FW: O8W-PM 35217268, 35224712, 35224713 - Bucks Creek 1101 Phase 1,2&3 -
Pre-Engineering Meeting

Bucks Creek 1101- PM# 35217268 Overview Map

Subject: O8W-PM 35217268, 35224712, 35224713 - Bucks Creek 1101 Phase 1,2&3 - Pre-Engineering Meeting

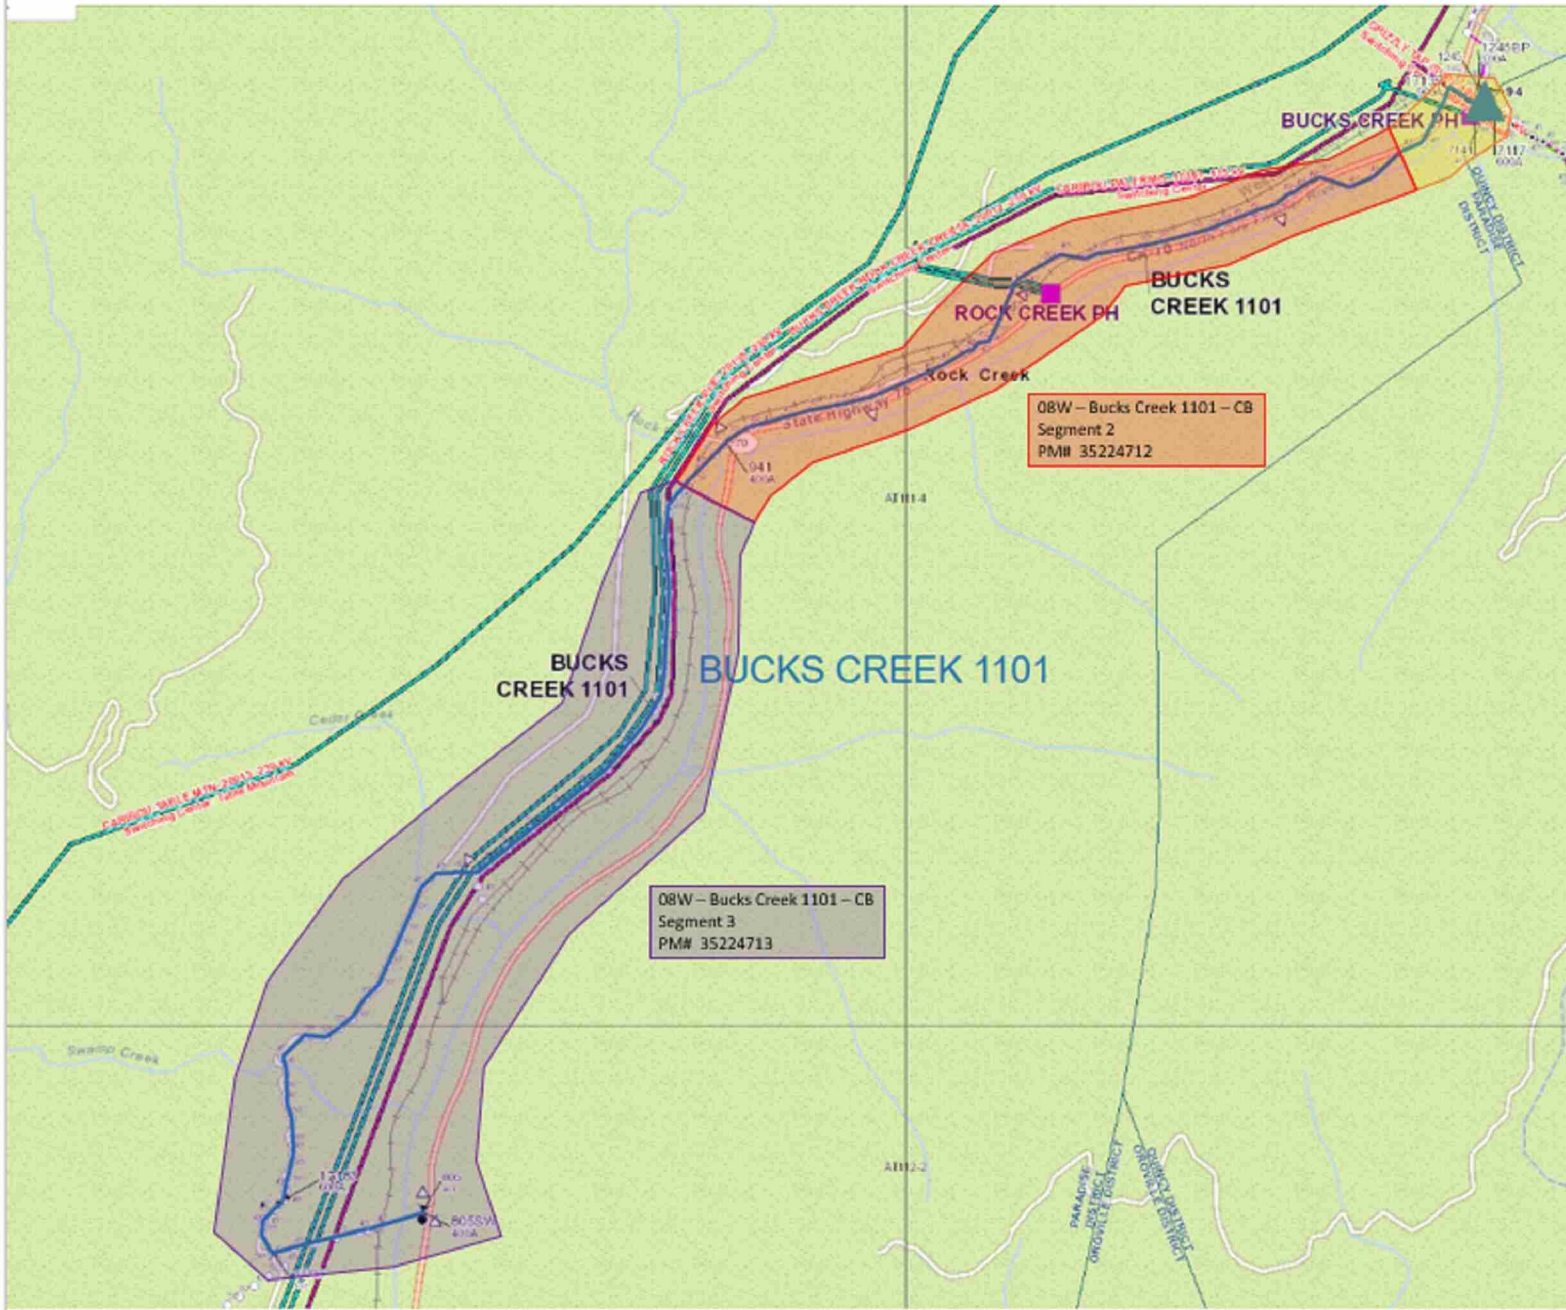
For Bucks Creek there is quite a bit of work surrounding Hwy 70 and we will need a Land Department Base Maps prepared for all 3 Orders. This will delay the EOD dates until these can be developed and provided to the Vendor... We will also need answers to the questions outlined by [REDACTED] below...
